**Freightliner
Service Bulletin**

Heater Valve Incorrect Plumbing

83-151

Fig. 1, Correct Heater Valve Plumbing

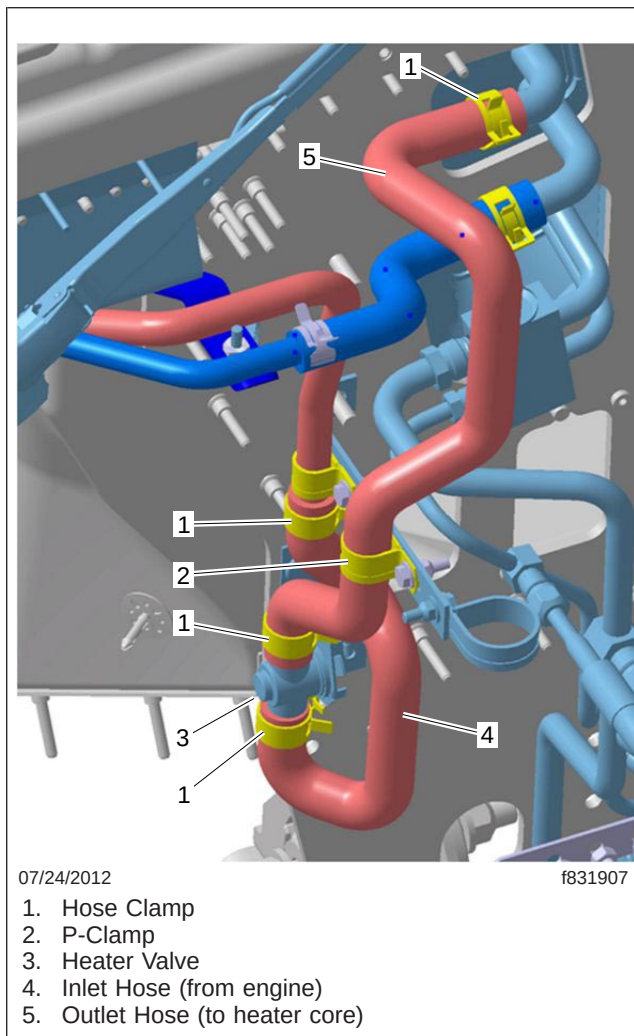
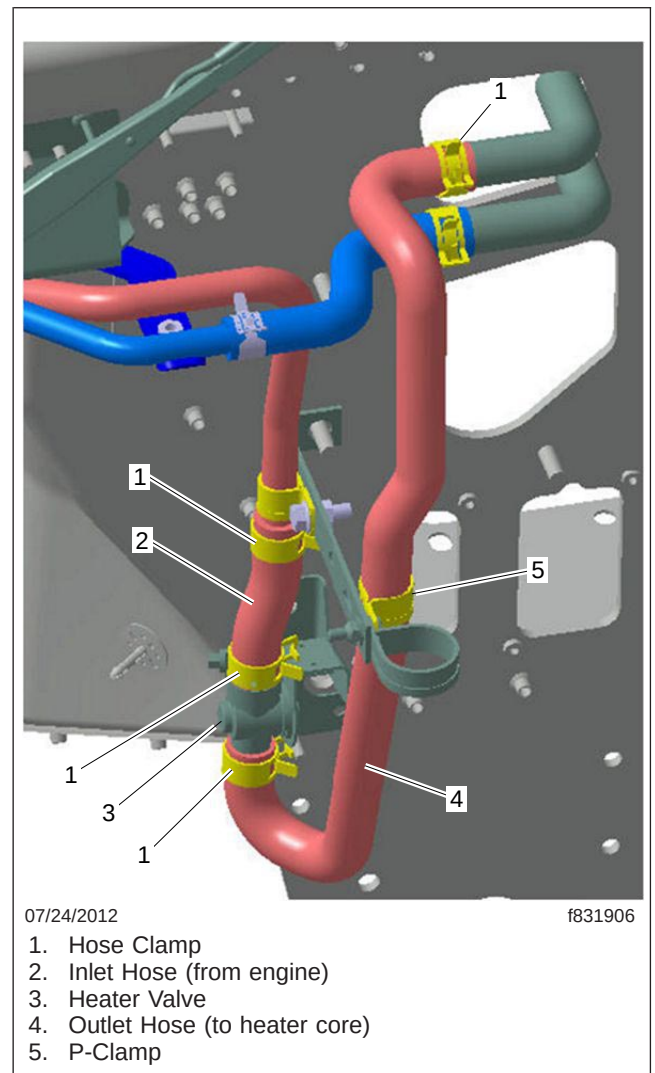
Some right-hand drive Century Class and Coronado vehicles have diminished A/C performance due to the heater valve being plumbed incorrectly. If the heater core feels warm with the heater off, check the plumbing on the heater valve. The valve should be plumbed as shown in [Fig. 1](#). If the valve is plumbed as shown in [Fig. 2](#) replace the hoses with the ones listed in [Table 1](#) and route them as shown in [Fig. 1](#).

2. Allow the engine to cool before working on the cooling system.
3. Using hose pinch pliers, pinch off both heater hoses close to the engine block connections on the right side of the engine.
4. Remove the P-clamps as needed.
5. Remove the old hoses. See [Fig. 2](#).
6. Install the new hoses. See [Fig. 1](#).
7. Install the P-clamps. See [Fig. 1](#).
8. Remove the pinch pliers from the heater hoses.
9. Start the engine and check for leaks.
10. Check the coolant level. Add coolant if needed.

Replacement Hoses		
Description	Current Part	Replace with Part
Hose	48-25122-075	05-30788-000
Hose	05-29664-000	05-30567-000
